Exhibit A

Recommended Amendments to the 2018 International Building Code

****Figure R602.6.1; delete the figure and insert the following figure:**

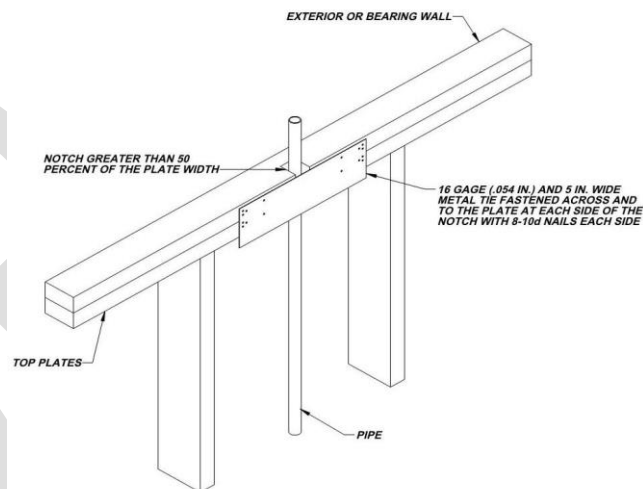
R602.6.1 Drilling and notching of top plate. When piping or ductwork is placed in or partly in an exterior wall or interior load-bearing wall, necessitating cutting, drilling or notching of the top plate by more than 50 percent of its width, a galvanized metal tie not less than 0.054 inch thick (1.37 mm) (16 Ga) and 4 ½ inches (38) mm 5 inches (127 mm) wide shall be fastened across and to the plate at each side of the opening with not less than eight 10d (0.148 inch diameter) having a minimum length of 1 ½ inches (38 mm) at each side or equivalent. Fasteners will be offset to prevent splitting of the top plate material. The metal tie must extend a minimum of 6 inches past the opening. See figure R602.6.1. {Remainder unchanged}

(Amendment to 2015 IRC carried forward to 2018 IRC also provides additional assurance of maintaining the integrity of the framing by spreading the nailing pattern.)

ADD: Figure: 25 TAC §265.186 (e) (6)

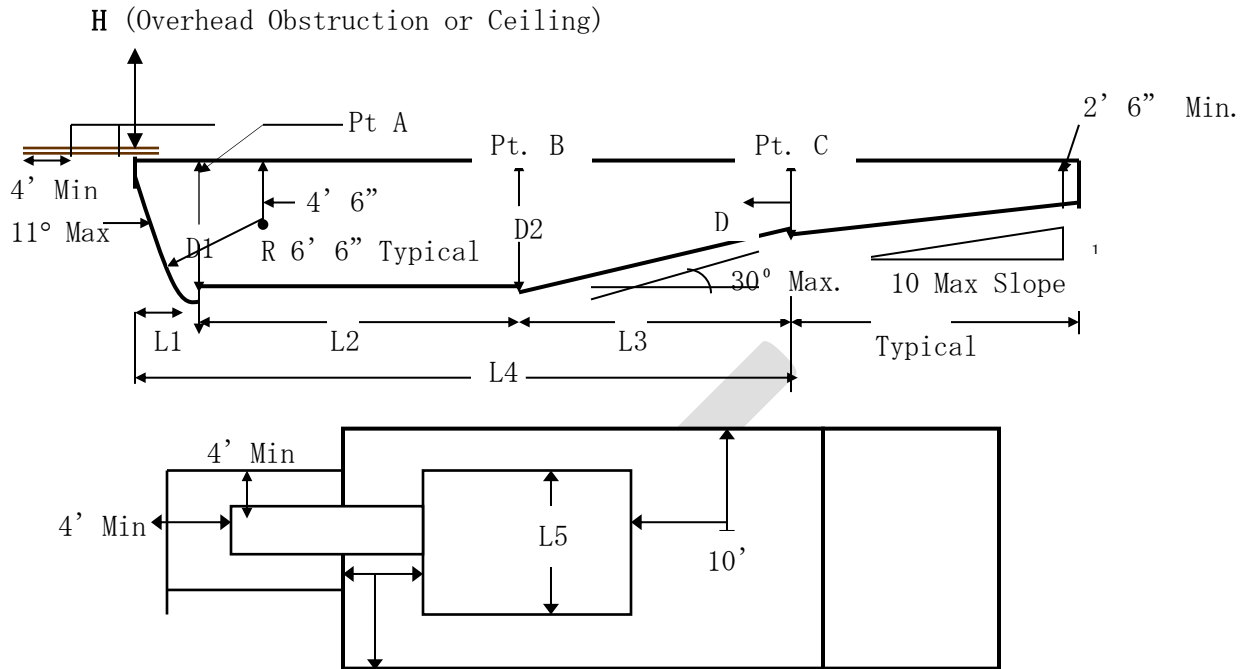
402.12 Water envelopes. The minimum diving water envelopes shall be in accordance with ~~Table 402.12 Texas department of State Health services, Administrative Code Title 25, Chapter 265, Section 186 (e) and Figure: 25 TAC 256.186 (e) (6).~~ (Delete Table 402.12 and Figure 402.12)

(Reason: To avoid conflict with 25 TAC Chapter 265.)

Maximum Diving Board Height Over Water	¾ Meter	1 Meter	3 Meters
Max. Diving Board Length	12 ft.	16 ft.	16 ft.
Minimum Diving Board Overhang	2 ft. 6 in.	5 ft.	5 ft.
D1 Minimum	8 ft. 6 in.	11 ft. 2 in.	12 ft. 2 in.
D2 Minimum	9 ft.	10 ft. 10 in.	11 ft. 10 in.
D3 Minimum	4 ft.	6 ft.	6 ft.
L1 Minimum	4 ft.	5 ft.	5 ft.
L2 Minimum	12 ft.	16 ft. 5 in.	19 ft. 9 in.
L3 Minimum	14 ft. 10 in.	13 ft. 2 in.	13 ft. 11 in.
L4 Minimum	30 ft. 10 in.	34 ft. 7 in.	38 ft. 8 in.
L5 Minimum	8 ft.	10 ft.	13 ft.
H Minimum	16 ft.	16 ft.	16 ft.
From Plummet to Pool Wall at Side	9 ft.	10 ft.	11 ft. 6 in.
From Plummet to Adjacent Plummet	10 ft.	10 ft.	10 ft.
